VALLEY AVENUE YARD  
A PORTION OF SECTION 16, TOWNSHIP 20, RANGE 04, W.M.,  
PUYALLUP, PIERCE COUNTY, WASHINGTON  
PRELIMINARY SITE PLAN

SHEET TITLE: PRELIMINARY SITE PLAN	CLIENT: 1124 VALLEY AVE, LLC 550 S MICHIGAN STREET SEATTLE, WA 98108	CONTACT: KERMIT JORGENSEN PHONE: (206) 787-1475

DESIGNER: PH
ENGINEER: BA
DRAWN: PH
S 16 T 20 N R 04 E WM
DATE: 2022-03-01
REVISED:
PROJECT: 21-247
DWG NAME: 21-247-A

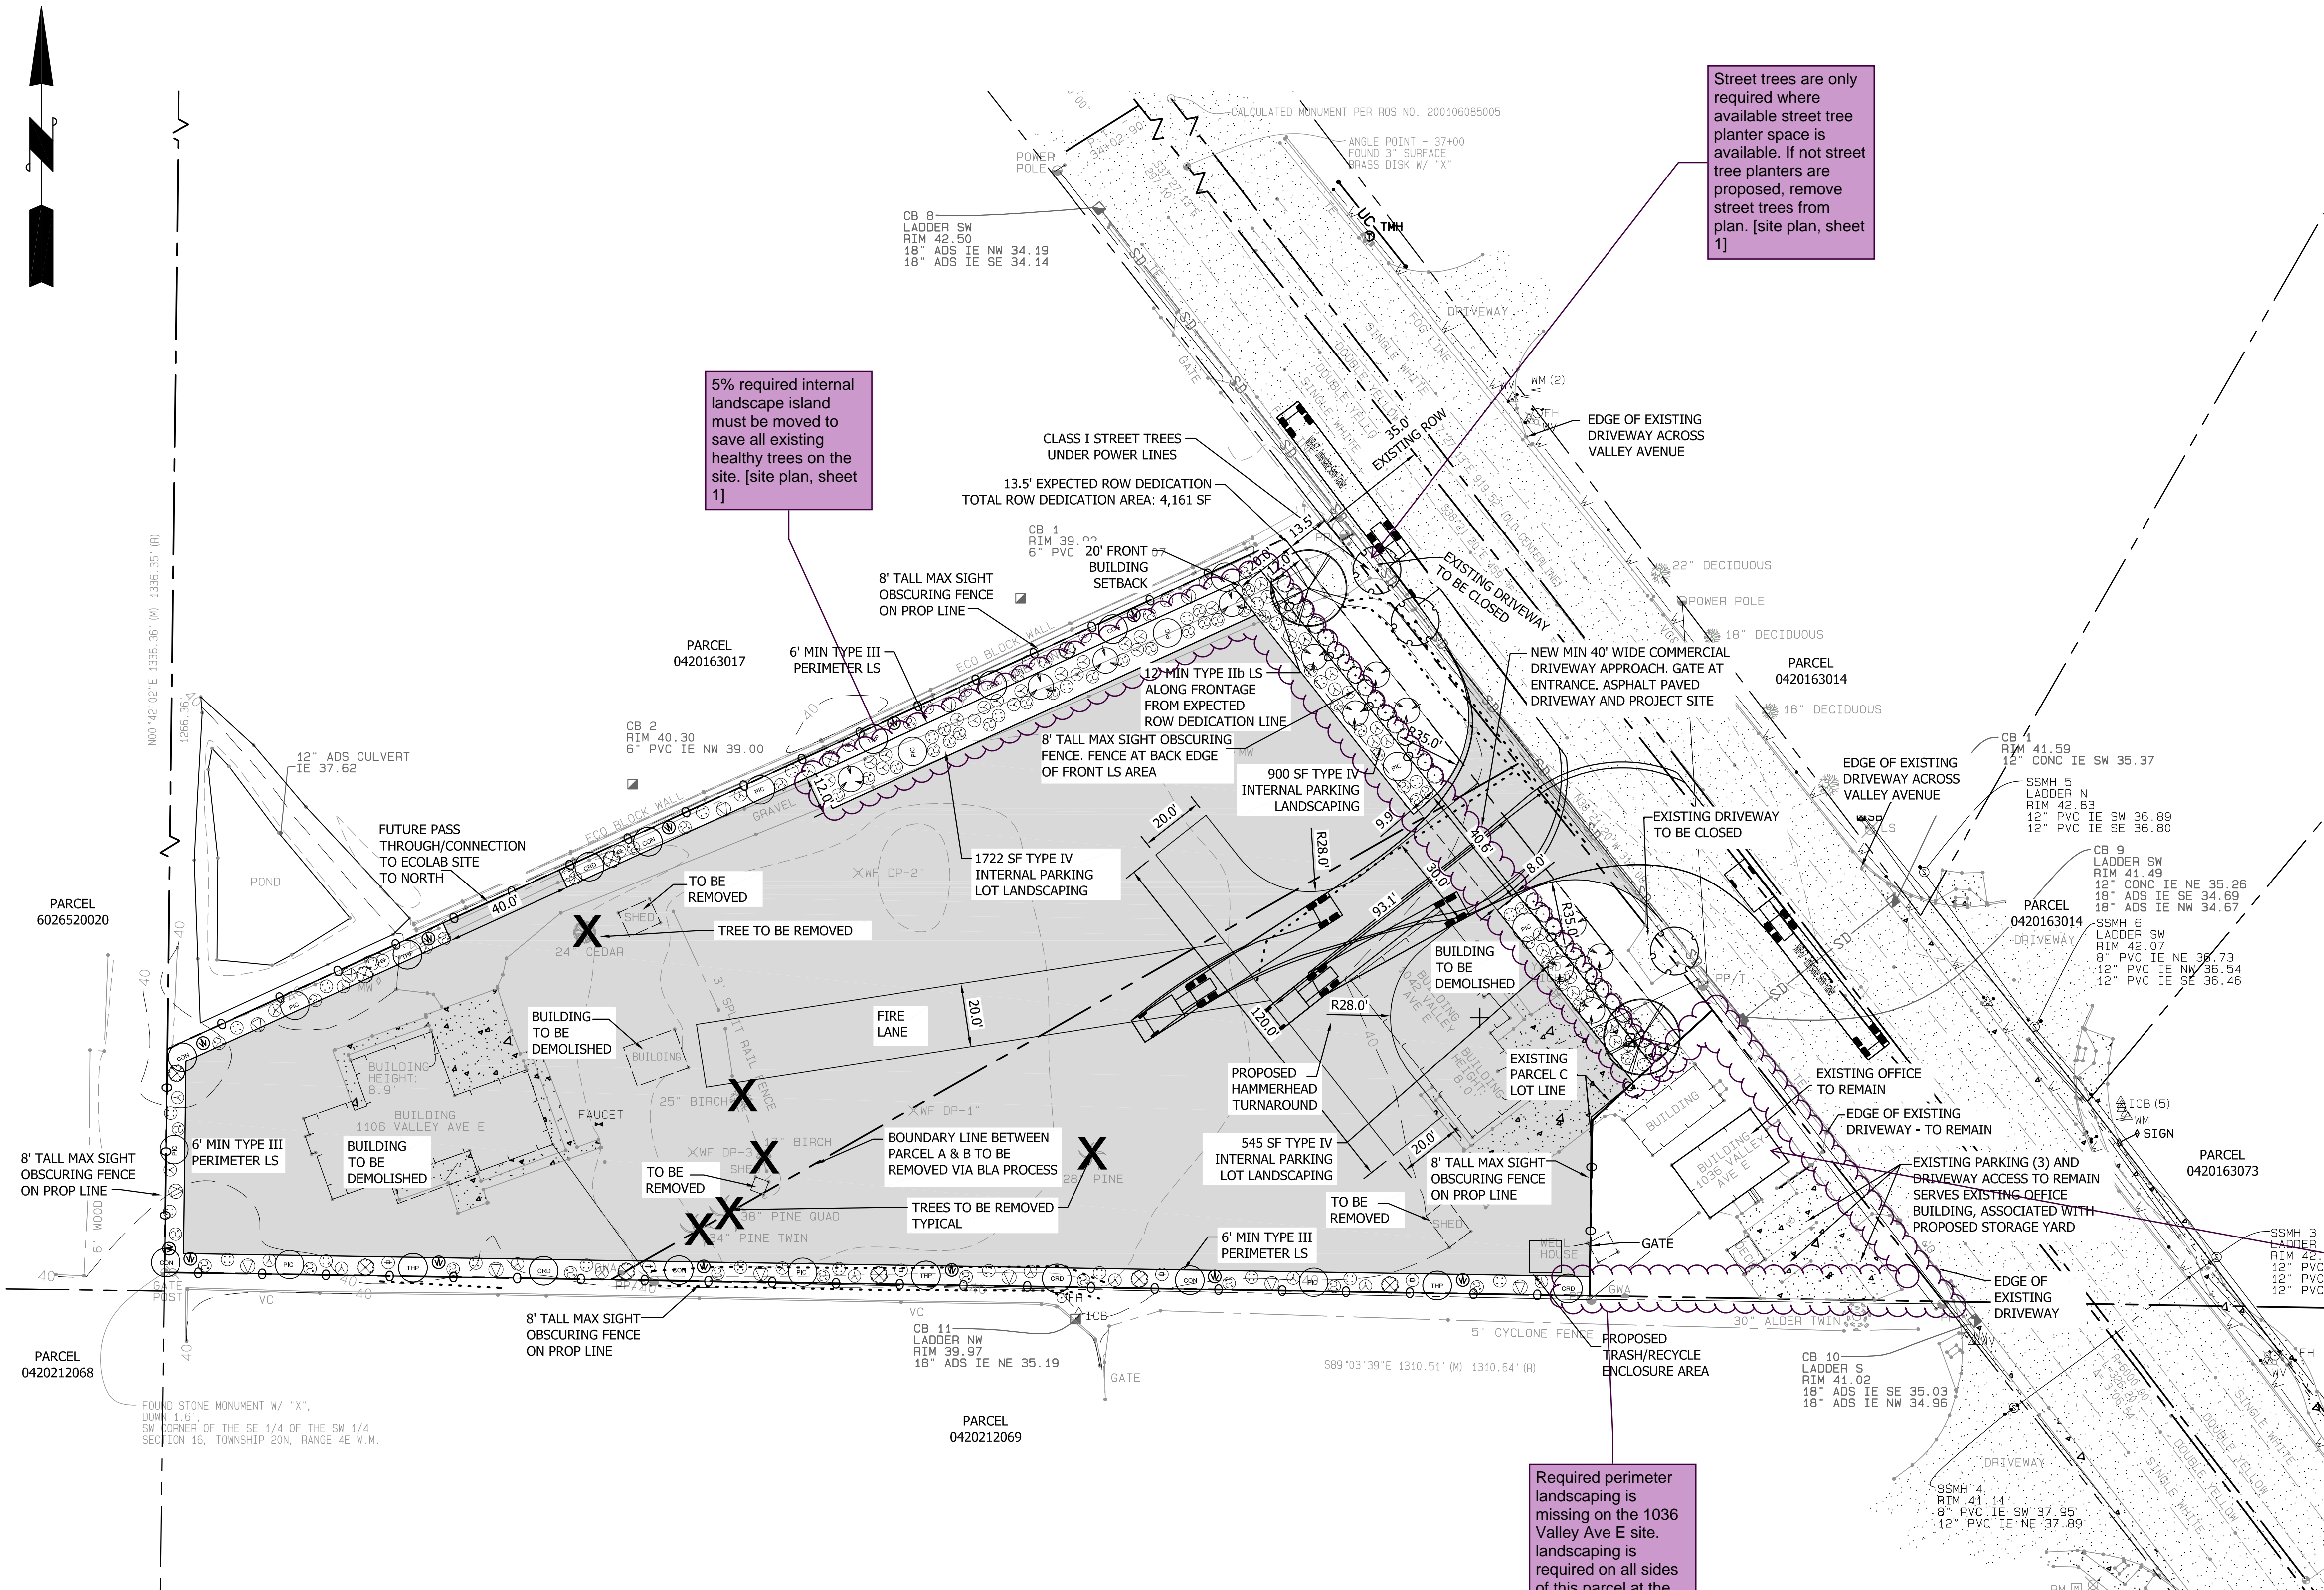
add parcel #0420163042 to project list. parking for this project is proposed at this site, and the existing building is proposed to be used to manage the truck parking facility. Revise plans to show this parcel as part of this project.

Add existing total building area to remain site plan [ site plan, sheet 1]

Street trees are only required where available street tree planter space is available. If not street tree planters are proposed, remove street trees from plan. [site plan, sheet 1]

5% required internal landscape island must be moved to save all existing healthy trees on the site. [site plan, sheet 1]

Required perimeter landscaping is missing on the 1036 Valley Ave E site. landscaping is required on all sides of this parcel at the same widths as the truck storage parcel [site plan, sheet 1]
